TITLE: SOUTH FACING SLIPS INTERVENTIONS

ON BEHALF Of: NATIONAL HIGHWAYS LIMITED

PURPOSE: DEADLINE 5 SUMISSION FOR THE LUTON AIRPORT
EXPANSION DEVELOPMENT CONSENT ORDER

DATE: 14 NOVEMBER 2023

Figure 1 - Figure 3.26b Motorway Diverging Diagram described in DMRB CD122

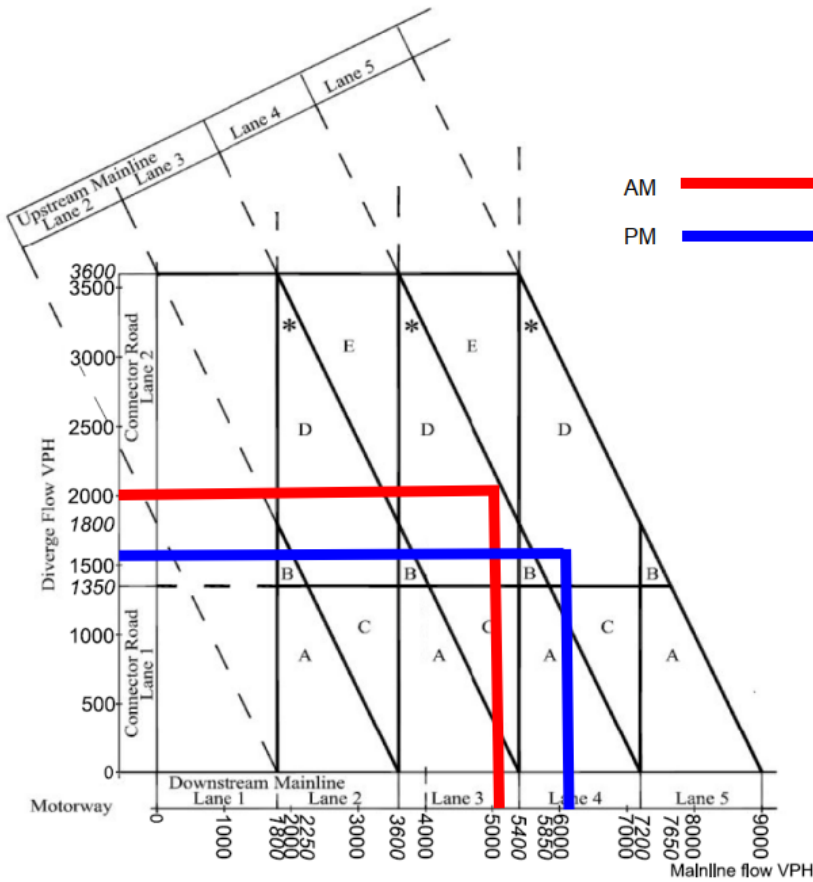
The selection of which diverge layout to be used is set out in CD 122 Figure 3.26b using vehicle per hour (VHP) traffic flows at AM and PM peaks.

Both the AM and PM Peak require a 'Layout D option 1 - ghost island lane drop', therefore this layout has been proposed for Intervention 1. This diverge layout can only be selected if the 5th northbound lane is extended to provide an additional lane which can be dropped at the diverge. If the 5th lane is not extended to the diverge then only a lower capacity diverge layout that uses a taper would be able to be selected, as per the existing provision, which Figure 1 above indicates is inadequate.

Figure 2 - Figure 3.30d Layout B intervention 2 - Two-lane auxiliary diverge described in DMRB CD 122

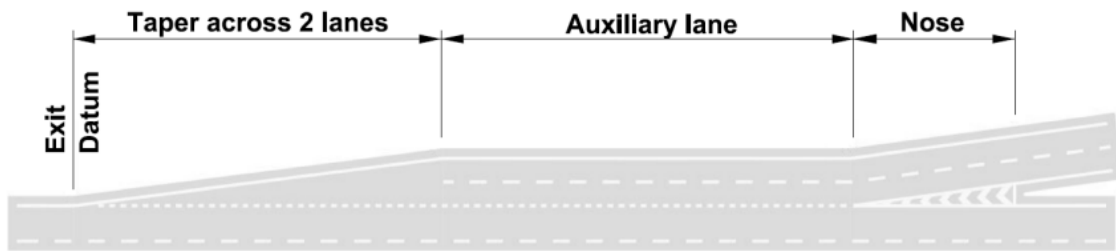
The existing Junction 10 southbound diverge arrangement is a 'Layout B option 2 - Two-lane auxiliary diverge':

Figure 3 - Figure 3.30g Layout D option 1 - ghost island lane drop described in DMRB CD 122

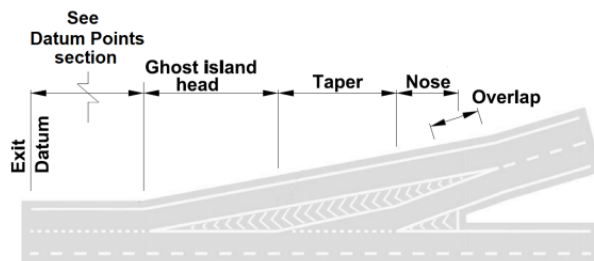
The intervention proposes to improve the existing arrangement with 'Layout D option 1 - ghost island lane drop':

Figure 4 - An extract from the interventions's drawing M1J10-NB-A-01

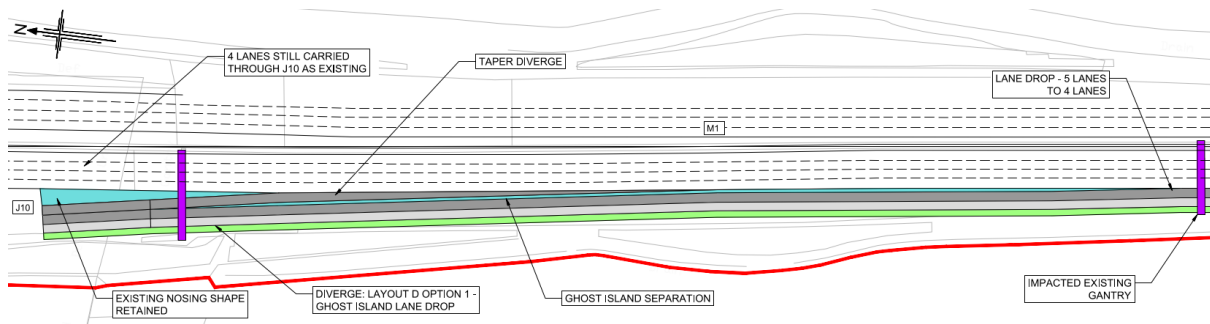
This intervention would likely require additional land beyond the existing highway boundary, the steepening of the existing earthworks, existing hard should being converted, or a narrowing of the carriageway cross section.

If additional land was to be acquired this would be approximately a 5 metre wide strip that is 1.6km long with a total area of 0.8 hectares. This would be effectively offset from the existing highway boundary, based on the assumption that no additional land was left spare by the previous scheme that defined the highway boundary.

The current land use is agricultural with no obvious ecological concerns beyond normal considerations.

Land acquisition/ planning methods should also be considered further, for example, DCO or landowner discussions.

Figure 5 - Figure 3.12b Motorway merging diagram described in DMRB CD 122

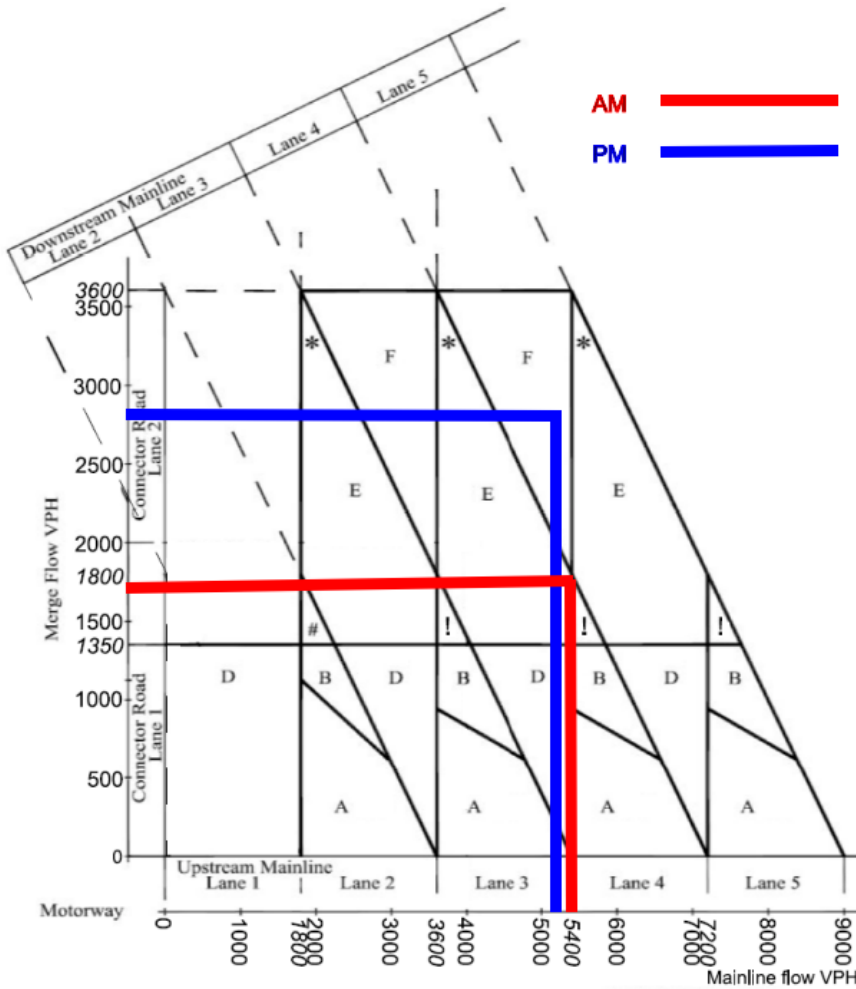
The AM Peak requires a '!' type layout which in this circumstance would be a 'Layout C - ghost island merge'. It should be noted that this is border line with a Layout E - lane gain with ghost island offside merge.

The PM Peak requires a 'Layout F - 2 lane gain with ghost island'. However, this has not been proposed due to significant constraints such as this type of layout including a lane gain function which would mean the mainline would gain and carry a 5th lane southbound to Junction 9.

Figure 8 - An extract from the intervention's drawing M1_J10_SB_Mer_Op2

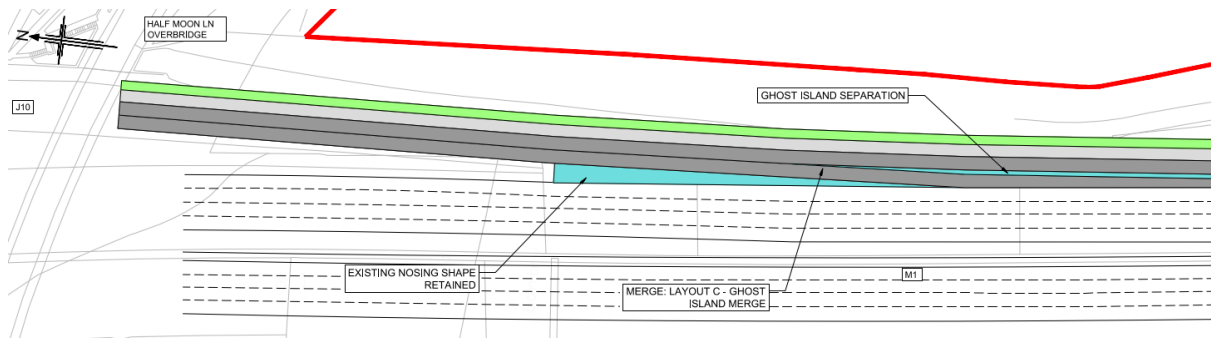
This intervention may be able to avoid any additional land requirements due to a wider existing cutting slope. This would need to be confirmed with a topographical survey.

If this was not possible, the acquisition of additional land beyond the existing highway boundary, the steepening of the existing earthworks, existing hard should being converted, or a narrowing of the carriageway cross section would be required.

If additional land was to be acquired this would be approximately a 5 metre wide strip that is 800 meters long with a total area of 0.4 hectares. This would be effectively offset from the existing highway boundary, based on the assumption that no additional land was left spare by the previous scheme that defined the highway boundary.

Figure 9 – Luton Rising Proposed Upgrade to M1 junction10

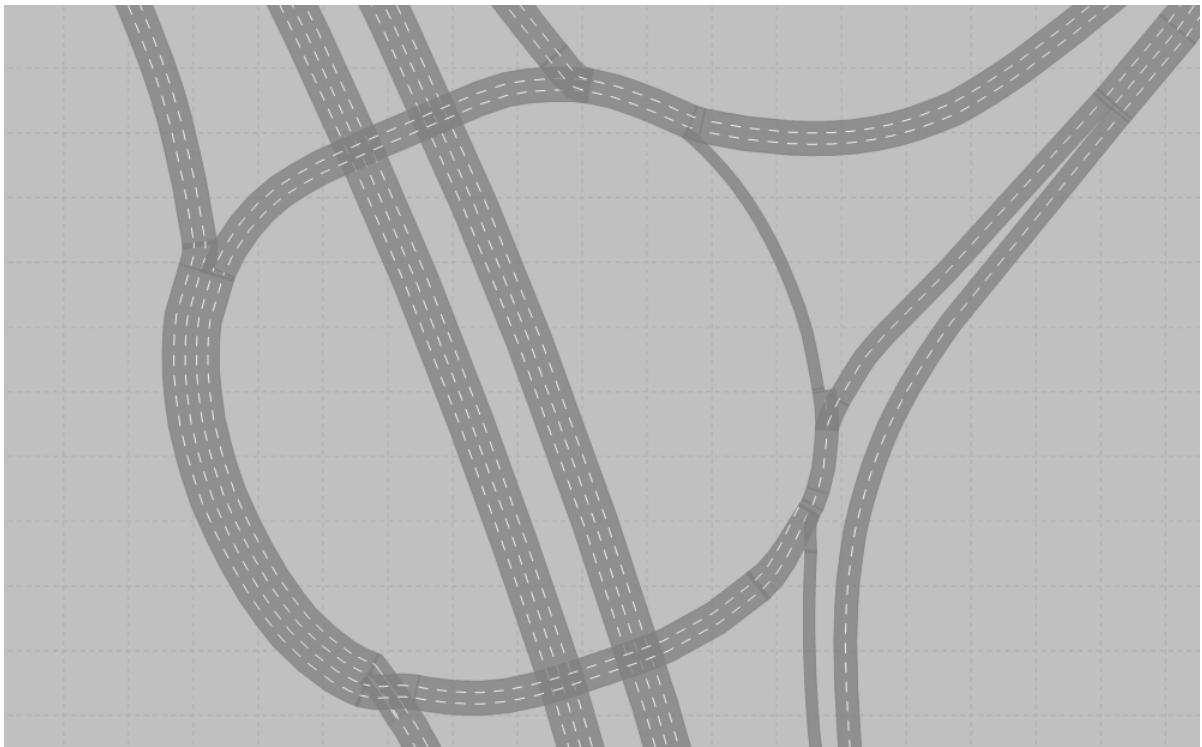
The two interventions have been assessed within the Luton Rising 2043 Do-something VISSIM model. With regard to the SRN, the key intervention within the model is a capacity upgrade and signalisation at the roundabout of Junction 10. The layout of this option is shown in Figure 9.

National Highways' principal concern is the ability to accommodate additional development-related traffic at an already congested junction. Whilst it is acknowledged that the Applicant's proposals provide mitigation to the circulatory carriageway, congestion remains on the south facing slip roads and their interaction with the mainline carriageway. These safety issues are not addressed by the Applicant's proposals.
